Source: Prestolite Leece-Neville Heavy Duty Systems
Bulletin No: TSB-1226 **Date:** May 2, 2023
Models: 8LHA2170VF (110-555JHO)
Subject: Terminal ID from 110-555JHO to AVI555P

This document will help identify terminal location variances.

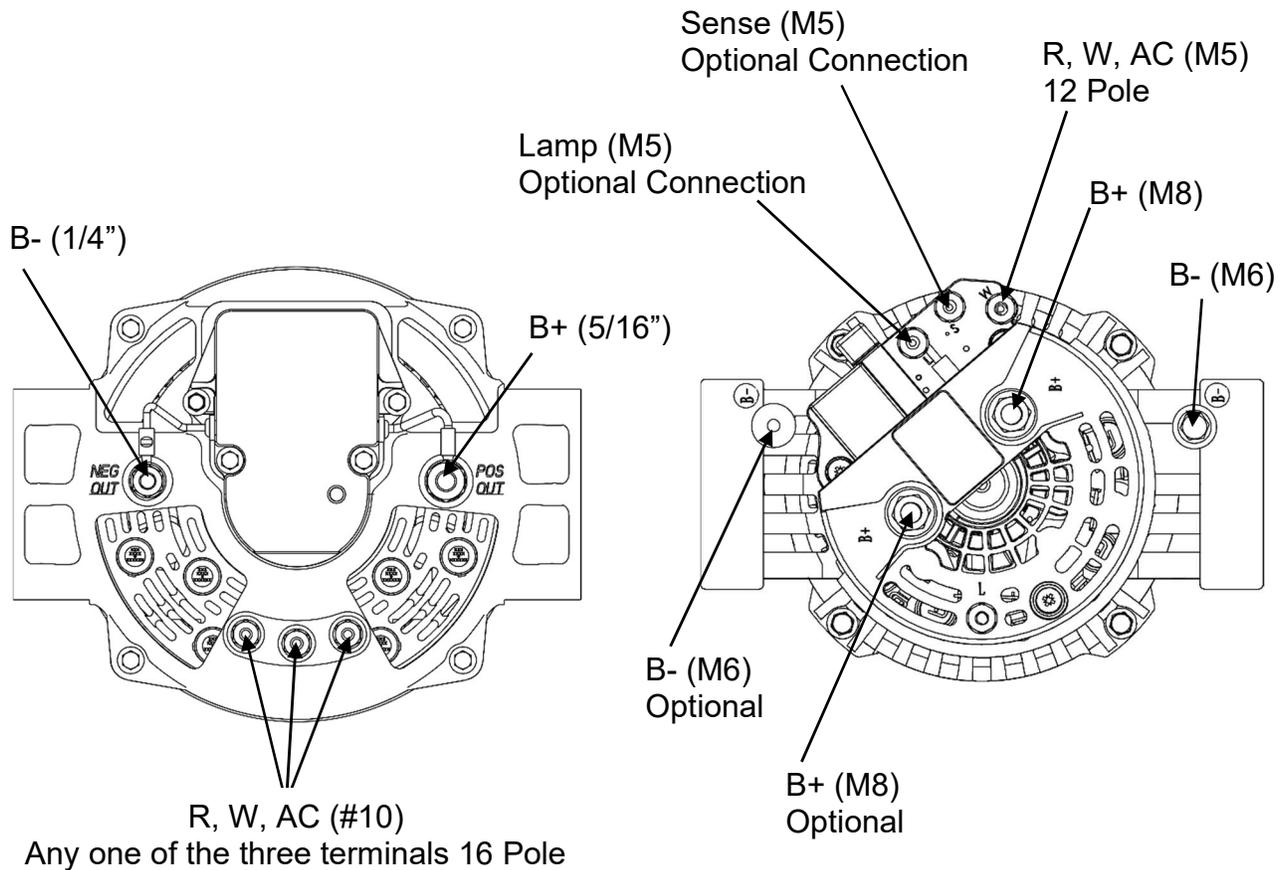
Note: Wire terminations and routing may require changes.
 AVI555P has internal cooling fans. External fan used on 110-555PHO alternator is not needed.
 Both AVI555P and 110-555PHO are self-excited machines.
 AVI555P is case ground where the 110-555PHO is insulated return.
